Change Order #11 includes 11 specific additions to the project and one deduct item.

CHANGE ORDER

PROJECT: (name, address)	Courthouse Square 555 Court Street NE Salem, Oregon 97301	CHANGE ORDER NUMBER:	11
		INITIATION DATE:	September 23, 1999
		ARCHITECT'S PROJECT NO.:	9828
TO: (contractor)	Pence/Kelly Construction, Inc. 2747 Pence Loop SE, P.O. Box 4109 Salem, Oregon 97302-8109	CONTRACT FOR:	General Construction
		CONTRACT DATE:	February 17, 1999

Subject: Change Columns to C14

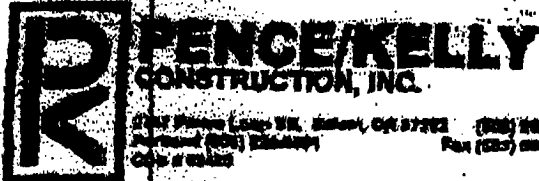
On Sheet S2.1.1, all columns on grid 3a - D to G and all columns on grid 2 - C to G are called out to be C16. Per phone conversation with Tim Terich, all of these columns need to be C14. Please confirm.

Revised North Parking Level Interior Columns Type C-16 to C-14 at 9 locations.

PROJECT NAME COURTHOUSE SQ
PROJECT NO. 40903.001.04
SUBJECT RFI # 236

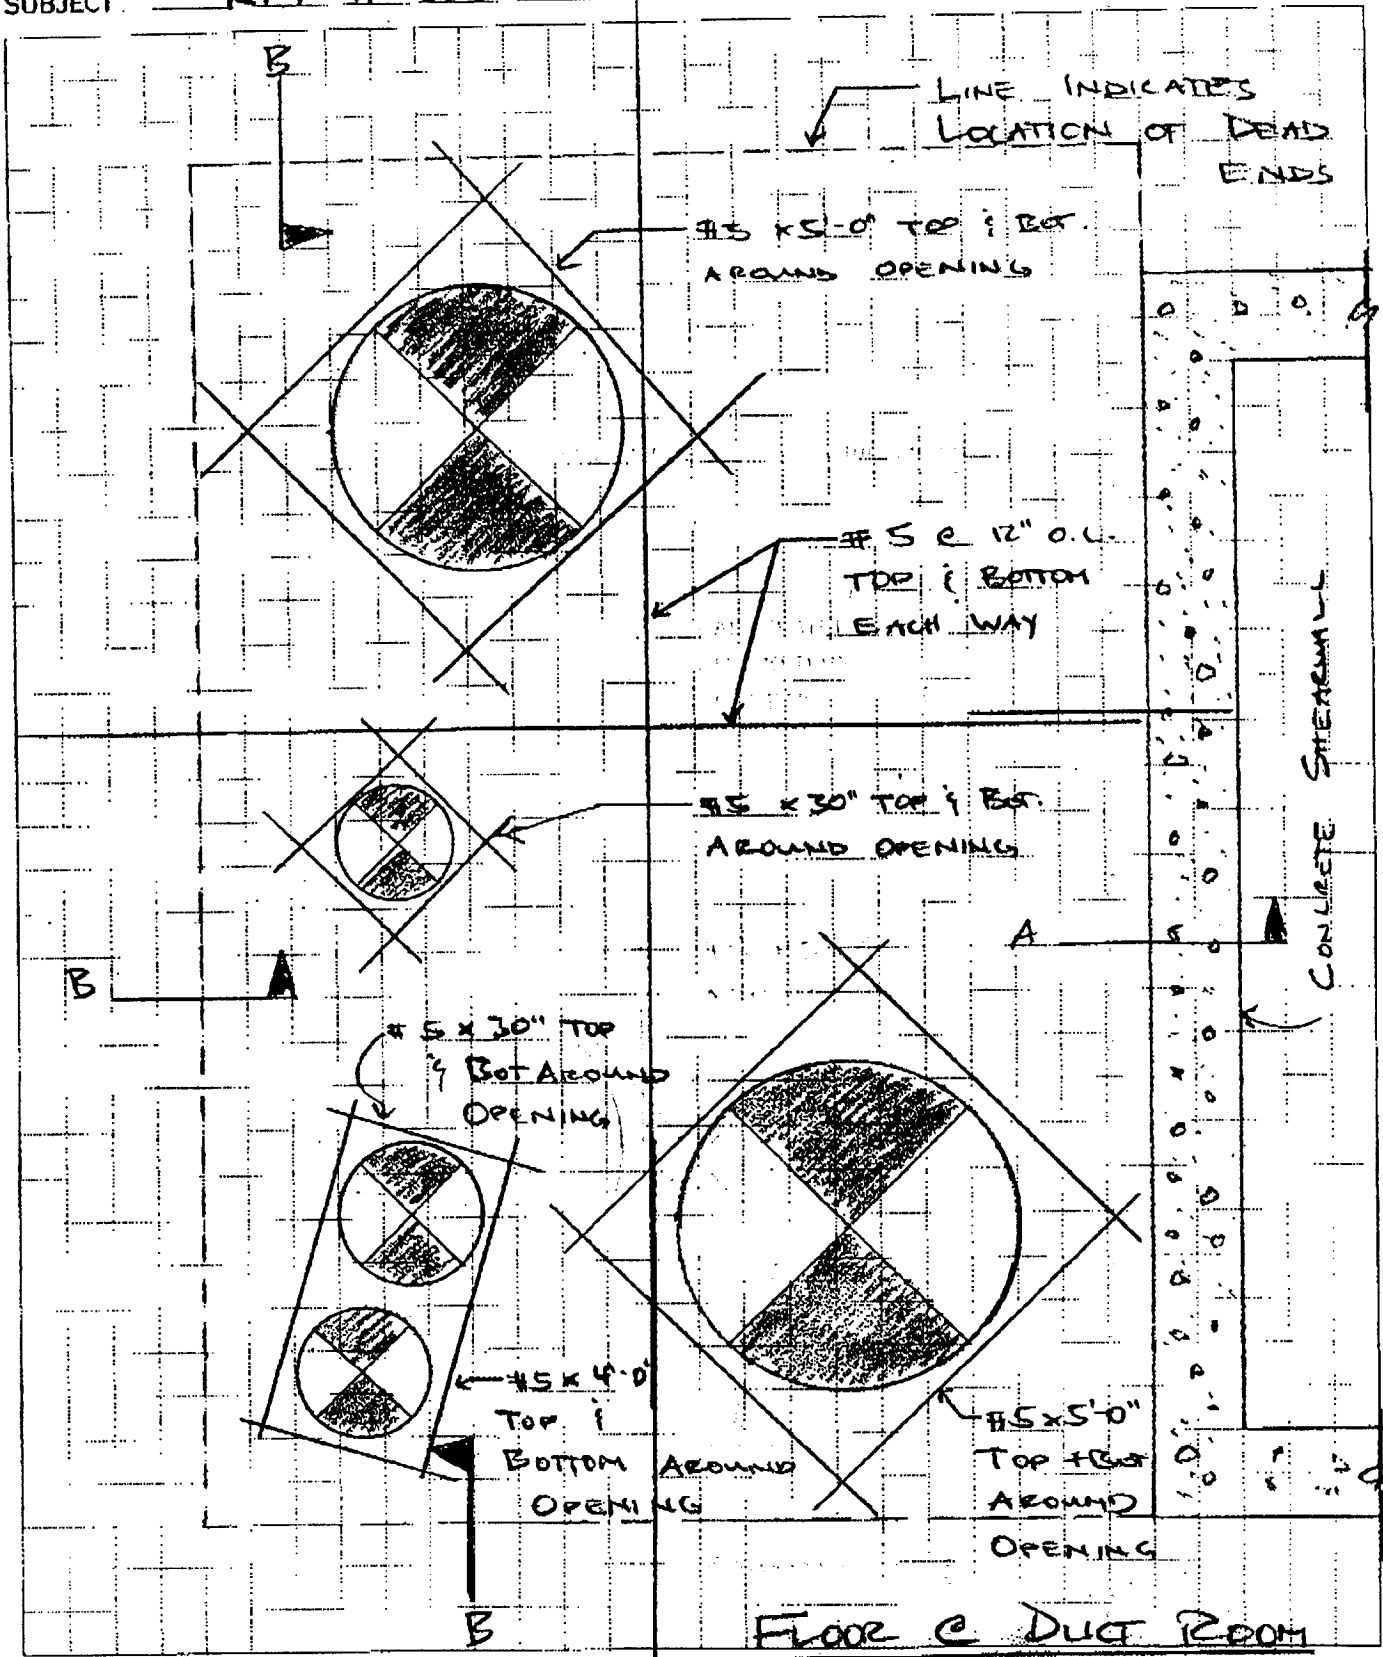
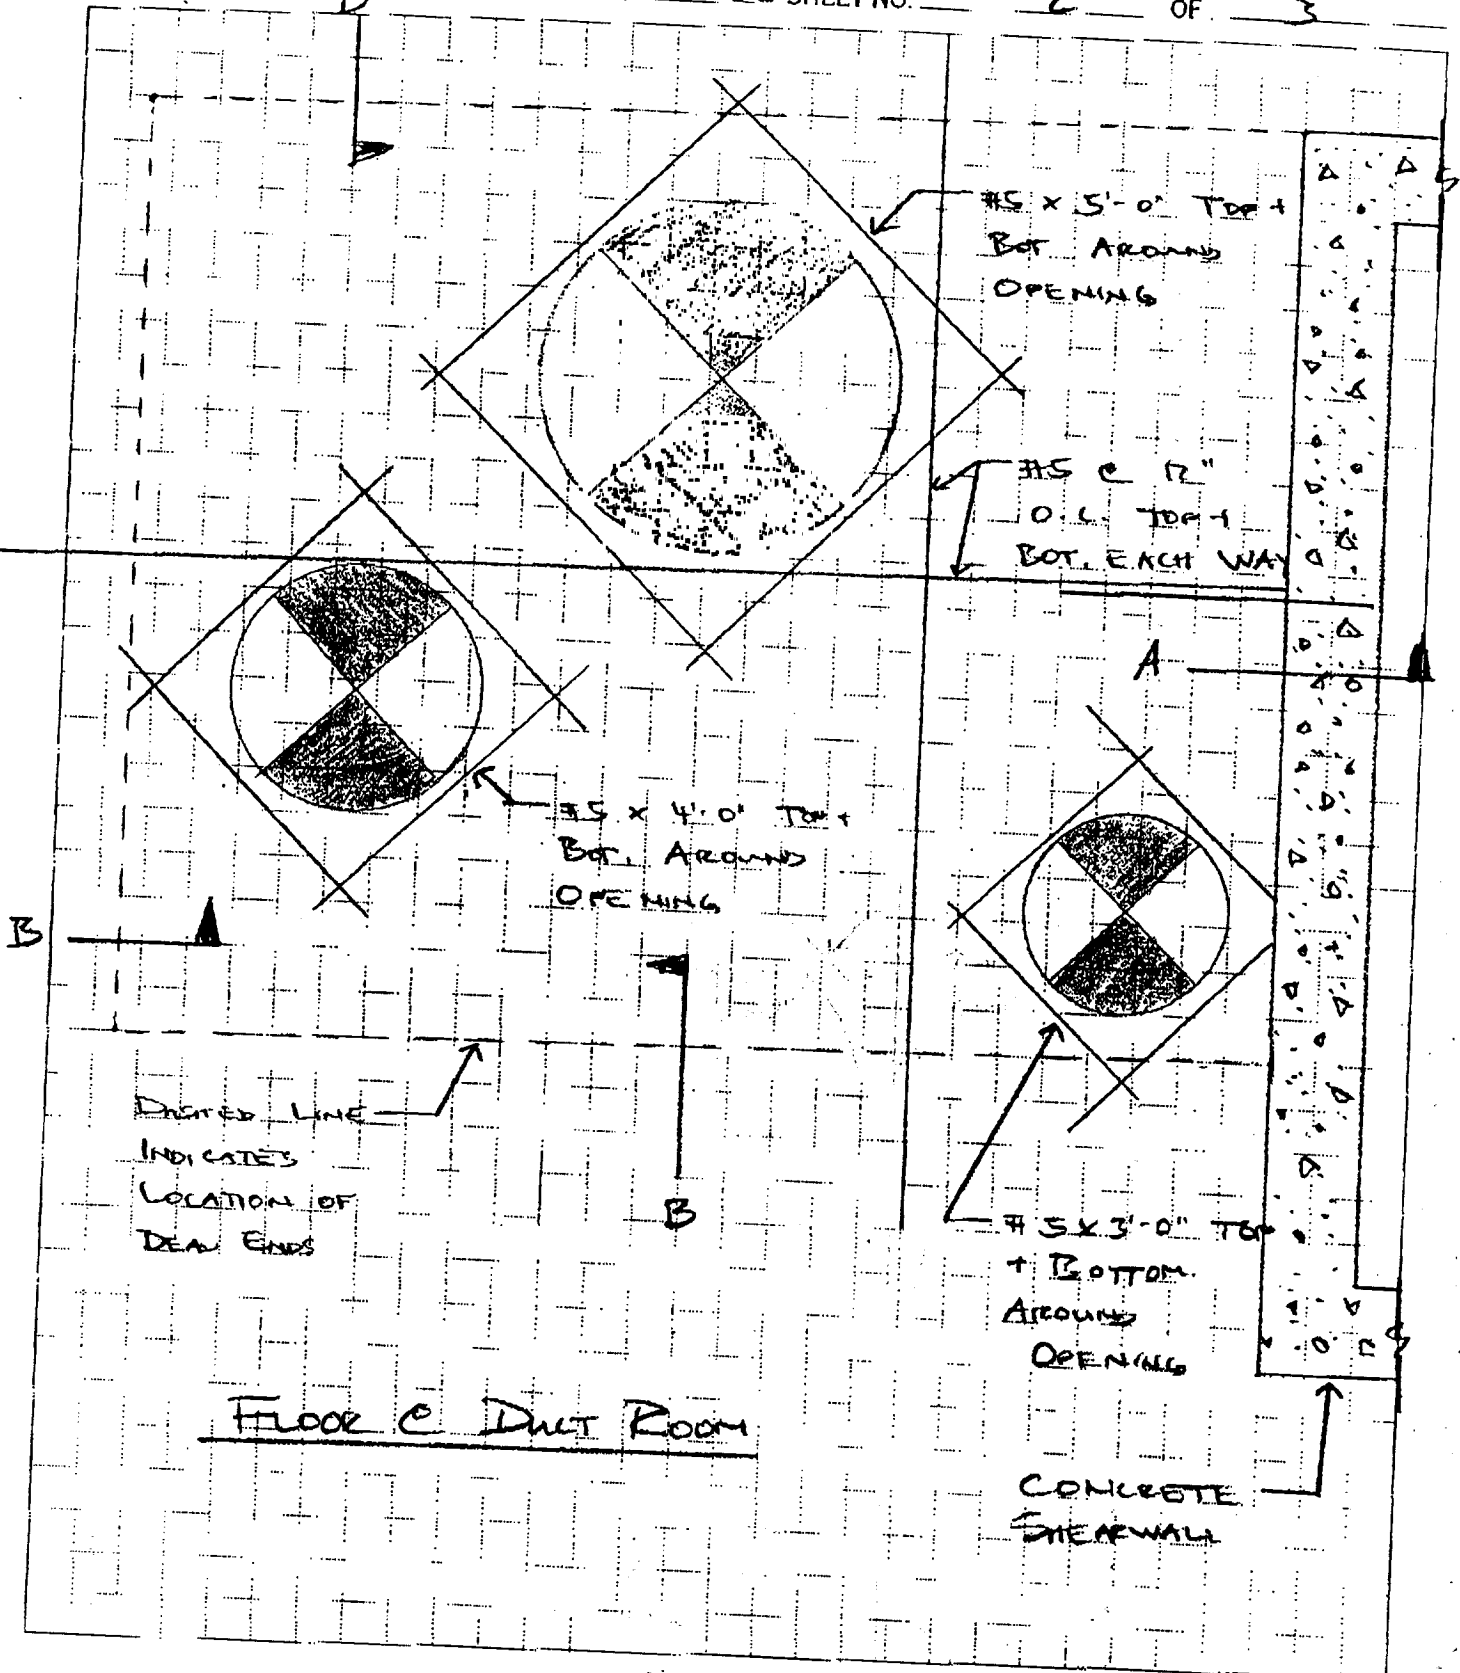
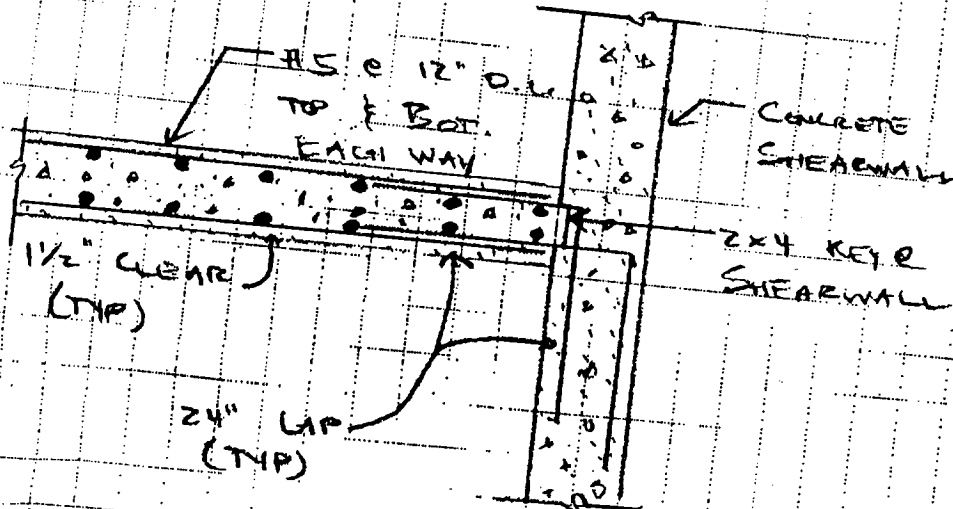
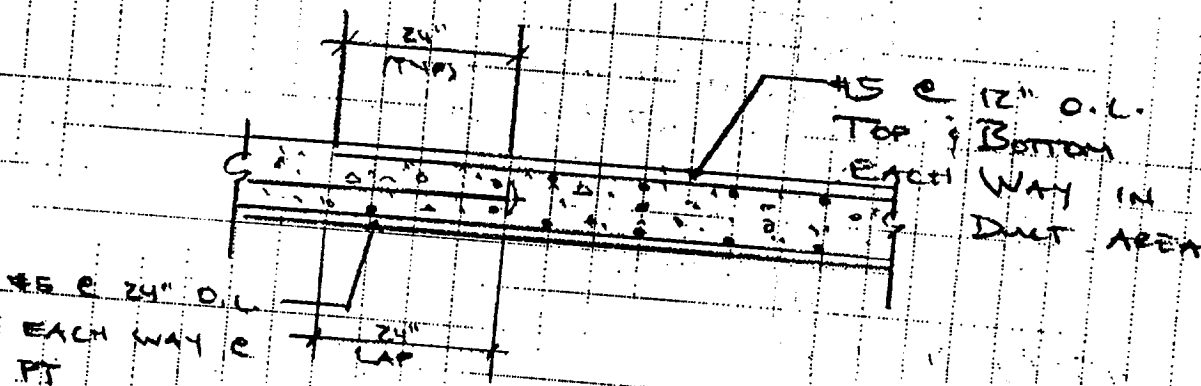
Architectural and Mechanical show the east and west chases, (just west of east and west stairs,) to be closed, with the concrete slab poured across. Structural sheet S2.3.1 shows these chases blocked out. Please clarify.

EXPLANATION OF CHANGE: RFI# 236
Add Reinforcing for Blockouts at 2nd Floor Slab Stairs.

Signed: John Gremmels**Response**By: JmoFirm: CWECDate: 6-25-99PLEASE SEE ATTACHED DETAILS
